CITY PLANNING COMMISSION

- APPLICATION:
- A. Negative Declaration
 - B. Schematic Plan Amendment to the Gateway Shopping Center PUD on 11.68 acres in the Shopping Center (SC-PUD) Zone.
 - C. Special Permit to allow an 86,279 square foot K-Mart Department Store, 18,900 square feet of retail shops and revised building pad locations.
 - D. Variance to allow a garden shop within the required 50 foot street sideyard set back in the SC-PUD Zone.

APPLC. NO. P86-362 MEETING DATE November 13, 1986 ITEM NO. 5

SITE PLAN

LANDSCAPE PLAN

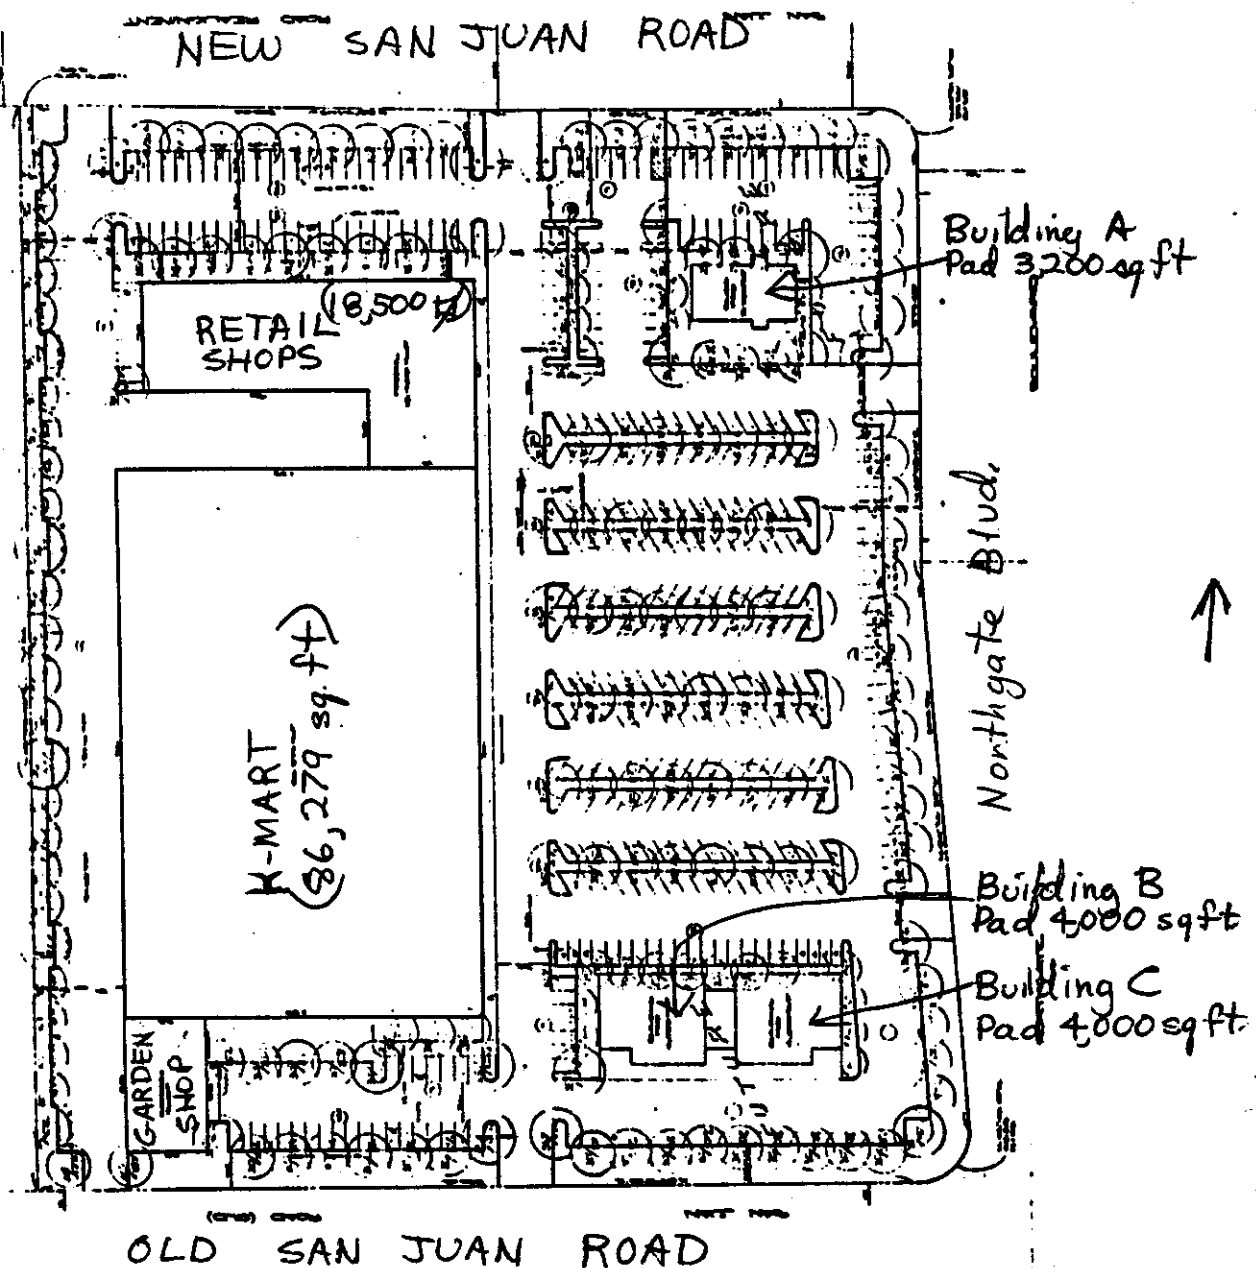
The applicant has prepared detailed landscaping plans (Exhibit - Landscape Plan). Under the City's Tree Shading Ordinance, a minimum of 50 percent of the lot will require shading within 15 years of planting. Also required are 25 foot deep landscape setbacks from the three road frontages with three to four foot high undulating berms with intensive tree coverage. Staff notes a mix of evergreen and deciduous trees on the site. It is recommended that 100 percent evergreen trees be planted along the west property line so that a permanent visual screen will grow along the rear of the building and serve as a buffer adjacent to the residential zoned properties. It is recommended that a 50 percent mix of evergreen and deciduous trees be used on remaining areas of the site. The minimum average density of trees along the public street frontages shall be one tree for every 20 lineal feet of street frontage. Staff recommends the staggering or clustering of trees to provide a random variety along the berming adjacent to street frontages.

Staff recommends that the applicant revise the landscaping and irrigation plans to show modifications to the parking lot including the addition of tree wells and providing two feet of landscaping into the vehicle overhang area. The City well

8. The applicant shall prepare detailed landscaping and irrigation plans for review and approval by the Planning Director which reflect all comments listed in Section O-Landscaping and Section C - Parking prior to issuance of building permits.

REAR ELEVATION (WEST)

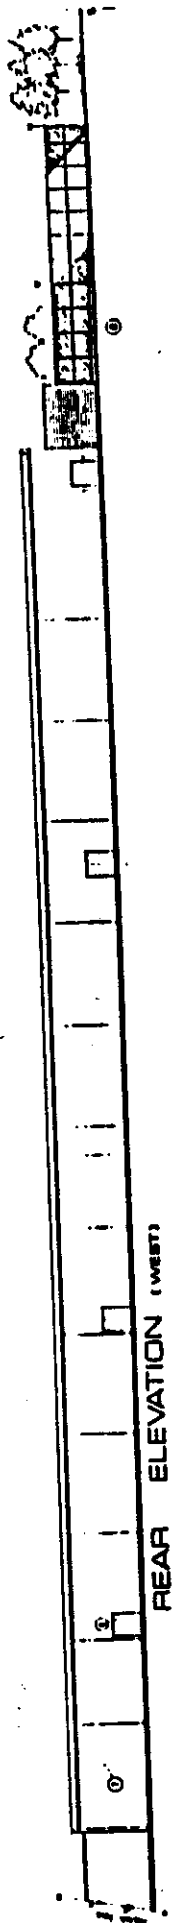
The applicant revised the rear building elevations to provide more vertical definition by the addition of wood trim elements. It has been the observation by the City's Design Review Coordinator that unless the wood trim is substantial in depth as width, such as 4" x 4" or 6" x 4" planks, boards affixed to the masonry wall tend to warp or become displaced. If wood trim is to be retained, dimension and method of building attachment is to be reviewed by the Planning Director.

Staff recommends a more permanent method of providing variety in placing two banks of split-face masonry block along the top of the rear elevation in place of the wood trim on either side of the stucco finish. The vertical gutter and downspout elements could also be split-face block popped out from the smooth painted masonry wall.

Staff recommends that if split-face masonry block be desired, that it be carried out as the trim element on all elevations. If wood trim is to be retained, then the boards will be required to be of sufficient size to not warp or become displaced.

- b. Modify the horizontal wood trim element to be of sufficient size to not warp, bend or become dislodged from the masonry wall.
 - c. If masonry split-face block is substituted for wood trim on the west elevation, that it be carried out throughout the building where feasible.

MODIFIED SITE PLAN

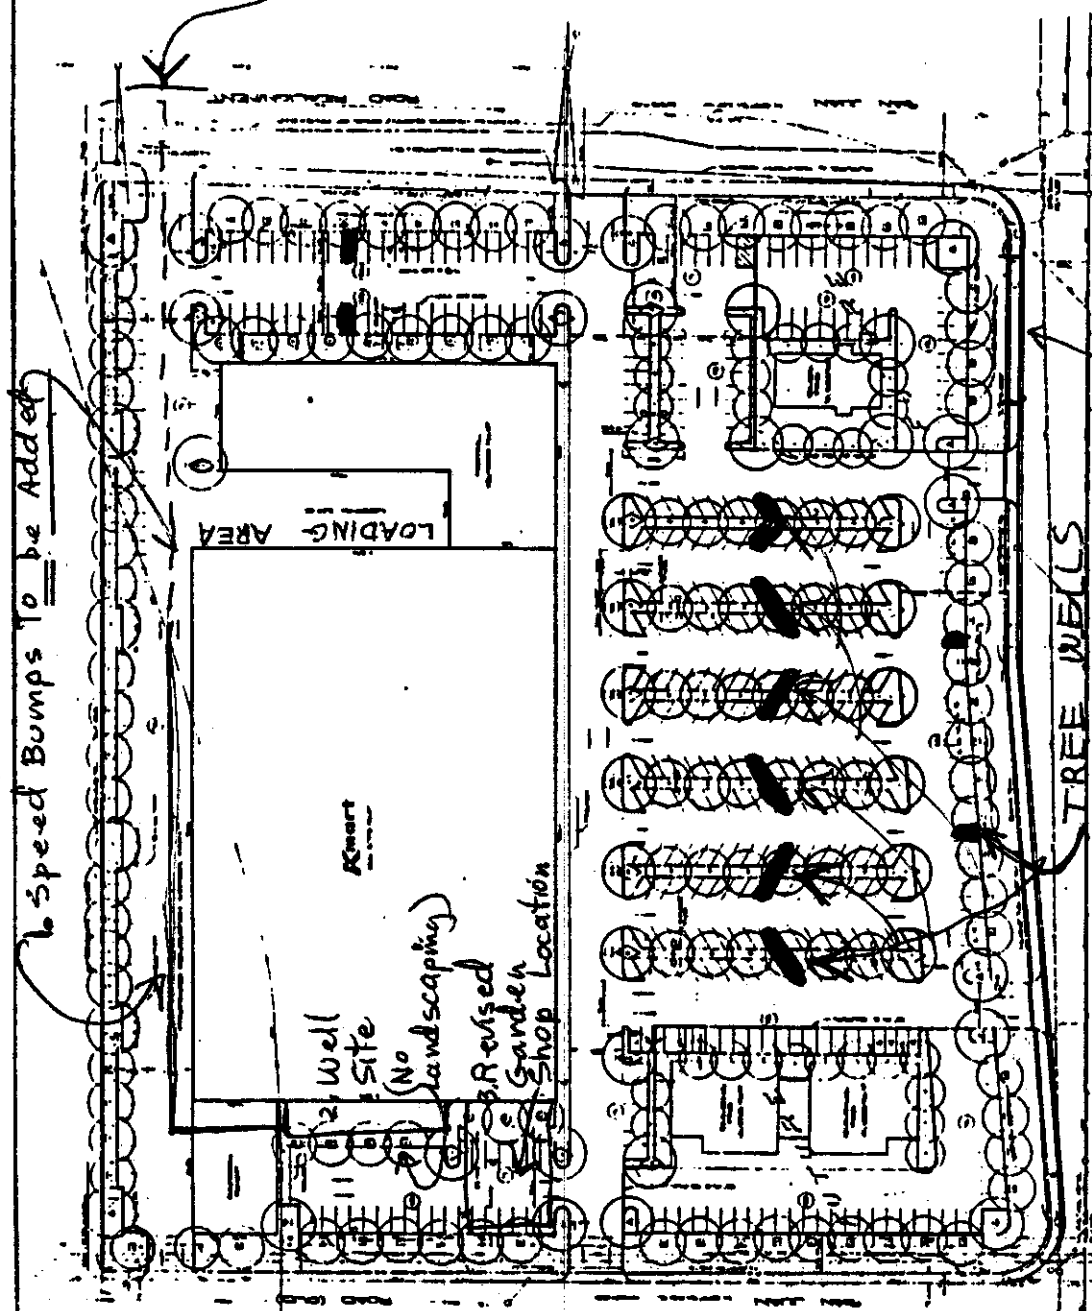
4. Add tree wells every 10 parking spaces where long rows of parking are shown,
5. Relocate 8" water line to San Juan Road
- 7.

6. Provide Bus Turnout or Shelter to satisfaction of Regional Transit

- a. Revise parking stalls to include a two foot vehicle overhang into a landscape planter strip.
 - b. Add tree wells so that no more than 10 consecutive parking spaces occur in a row - see Exhibit C.

4. The site plan shall reflect the requirements of Regional Transit as per Exhibit D.
